Sweet Home Mahler WRF Improvements Project

ADDENDUM NO. 3

MAHLER WRF PHASE 1 BID DOCUMENTS

E-011

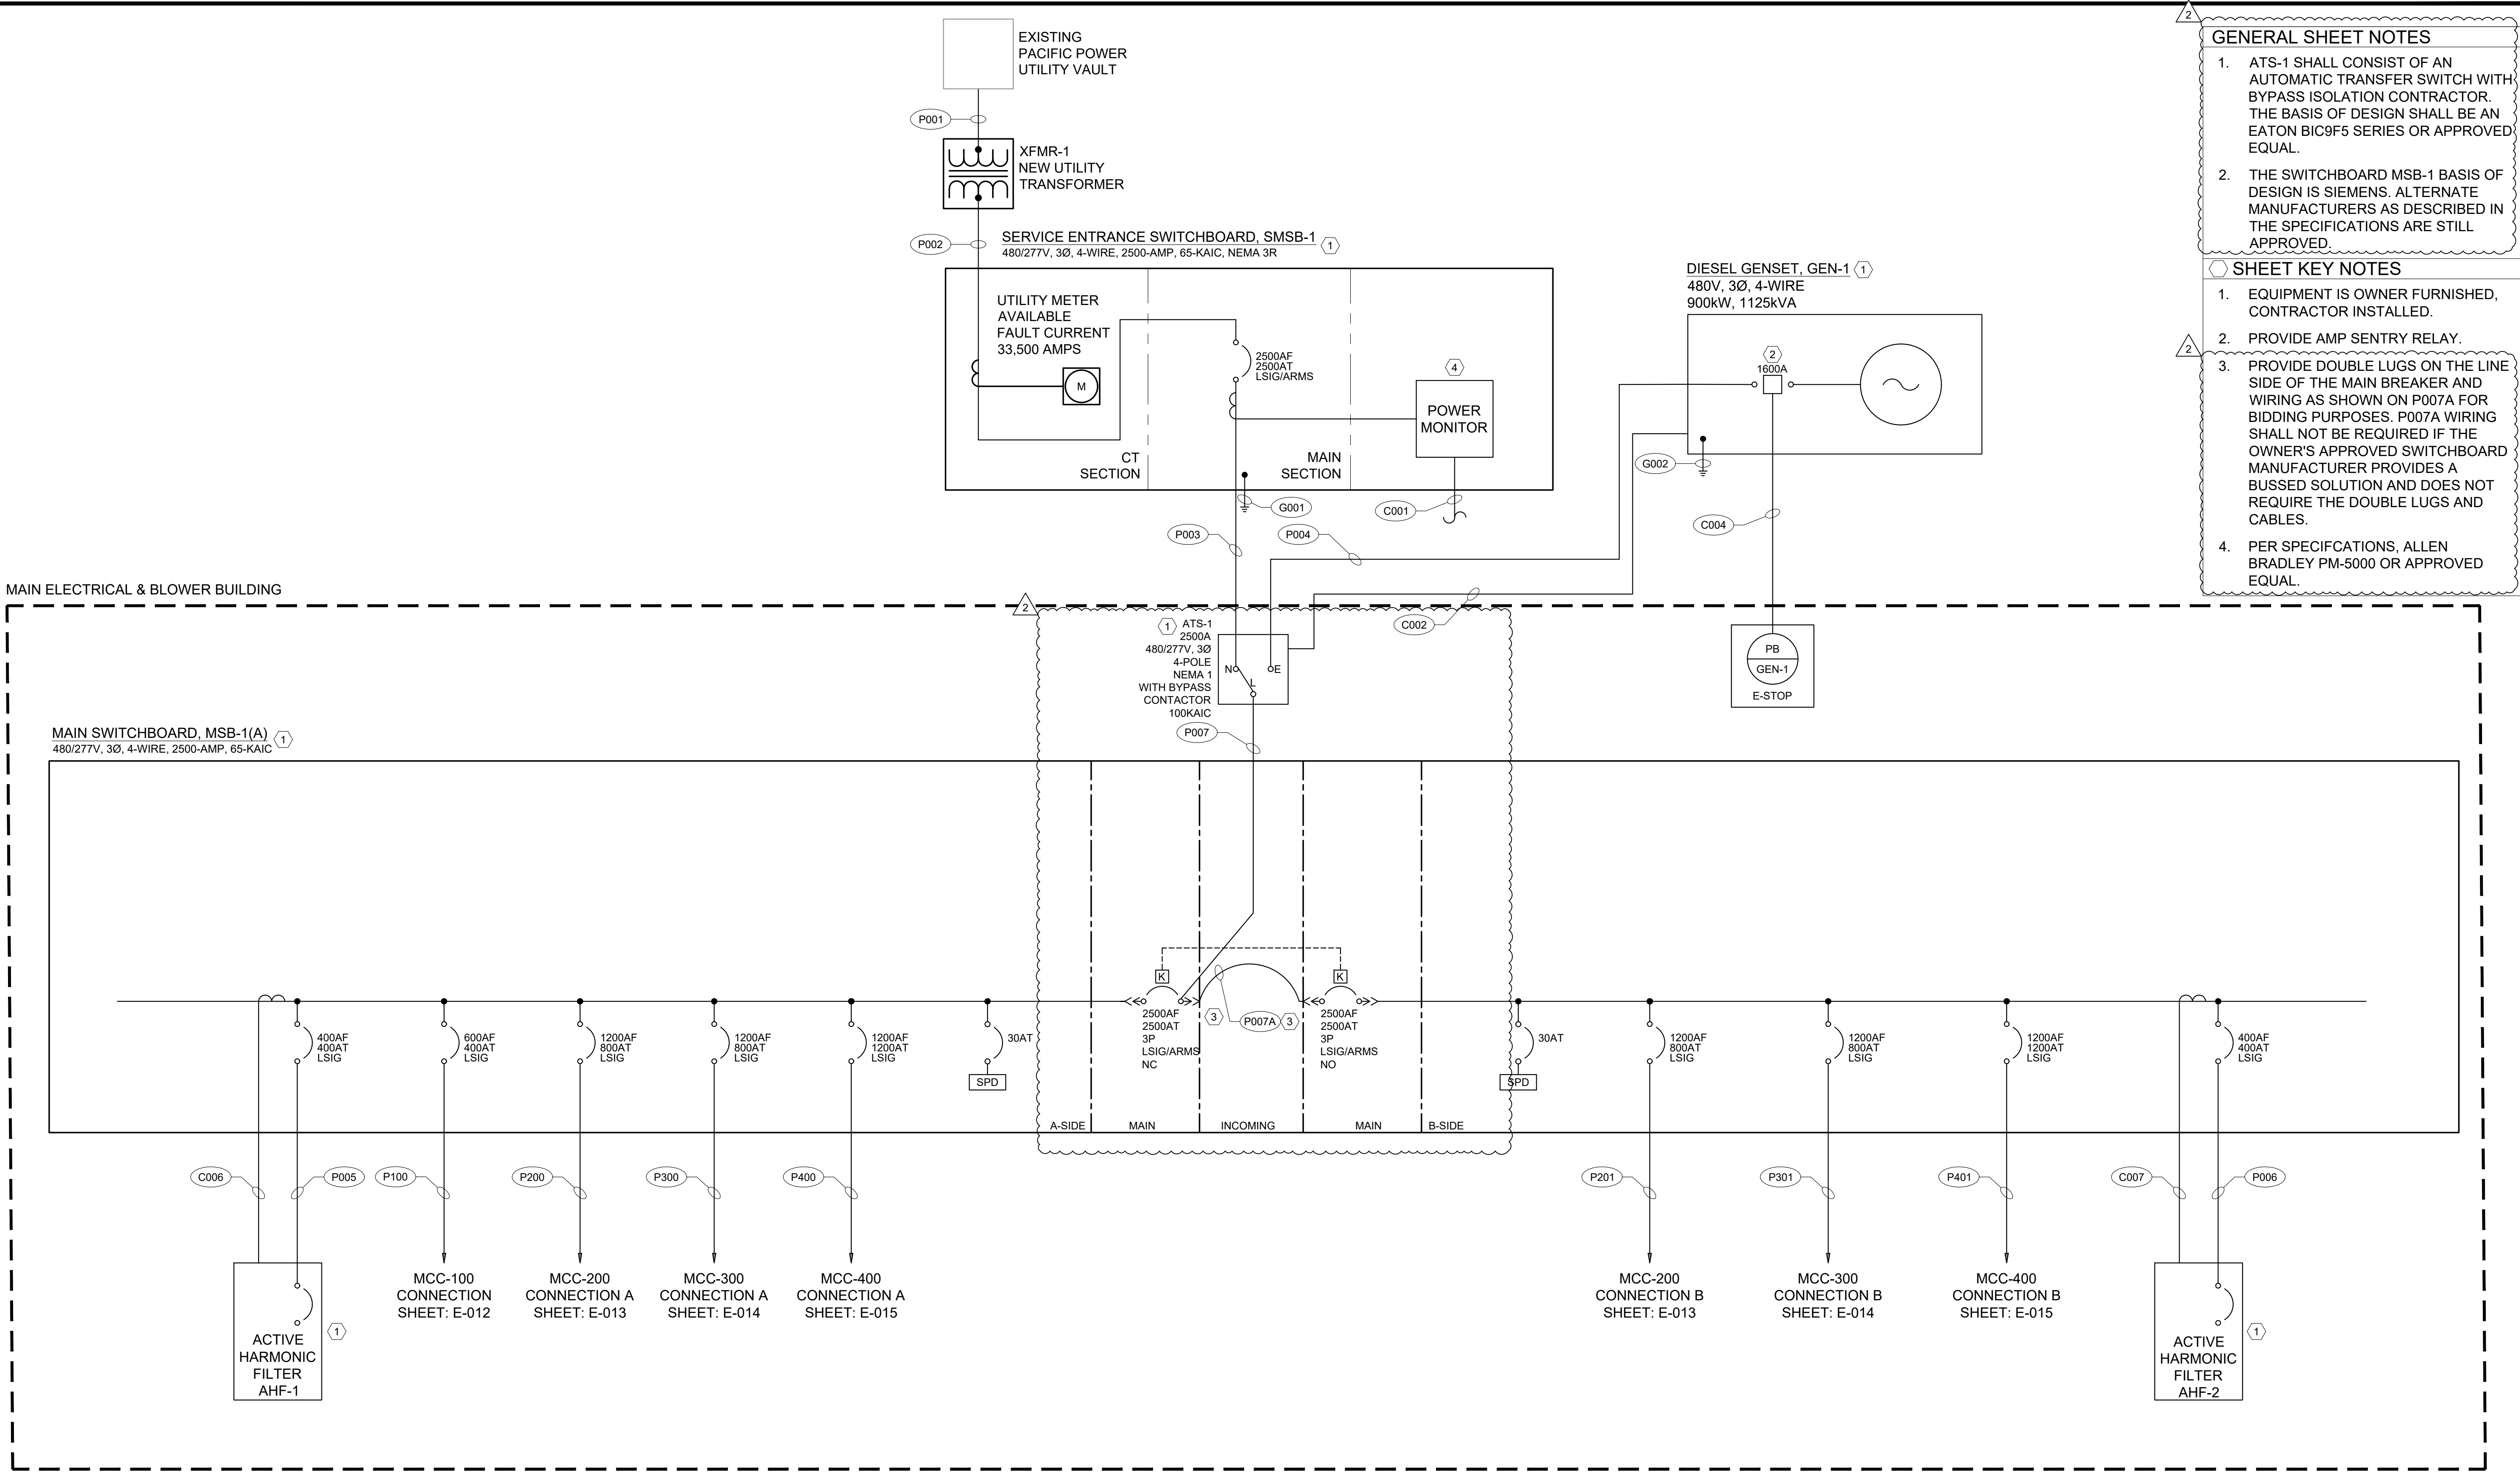
- GENERAL SHEET NOTES**
- ATS-1 SHALL CONSIST OF AN AUTOMATIC TRANSFER SWITCH WITH BYPASS ISOLATION CONTRACTOR. THE BASIS OF DESIGN SHALL BE AN EATON BIC9F5 SERIES OR APPROVED EQUAL.
 - THE SWITCHBOARD MSB-1 BASIS OF DESIGN IS SIEMENS. ALTERNATE MANUFACTURERS AS DESCRIBED IN THE SPECIFICATIONS ARE STILL APPROVED.
- SHEET KEY NOTES**
- EQUIPMENT IS OWNER FURNISHED, CONTRACTOR INSTALLED.
 - PROVIDE AMP SENTRY RELAY.
 - PROVIDE DOUBLE LUGS ON THE LINE SIDE OF THE MAIN BREAKER AND WIRING AS SHOWN ON P007A FOR BIDDING PURPOSES. P007A WIRING SHALL NOT BE REQUIRED IF THE OWNER'S APPROVED SWITCHBOARD MANUFACTURER PROVIDES A BUSSED SOLUTION AND DOES NOT REQUIRE THE DOUBLE LUGS AND CABLES.
 - PER SPECIFICATIONS, ALLEN BRADLEY PM-5000 OR APPROVED EQUAL.
